PRODUCT SAFETY RECALL

SUBJECT: Passenger Side Airbag Inflator End Cap Separation

MODELS: 2013 Buick Encore
2013 Chevrolet Spark

GM Recall #14211

3924797

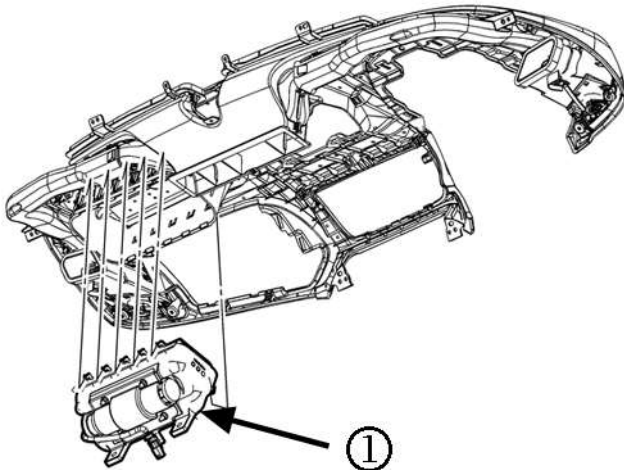
General Motors has decided that a defect which relates to motor vehicle safety exists in certain 2013 model year Buick Encore and Chevrolet Spark vehicles. Some of these vehicles may have a condition in which the front passenger airbag end cap could separate from the airbag inflator. In a crash, this may prevent the passenger airbag from deploying properly which could increase the risk of injury to the front passenger.

1. Remove the instrument panel airbag module (1). Refer to *Airbag Instrument Panel Module Replacement* in SI.
2. Install the new instrument panel airbag module. Refer to *Airbag Instrument Panel Module Replacement* in SI.
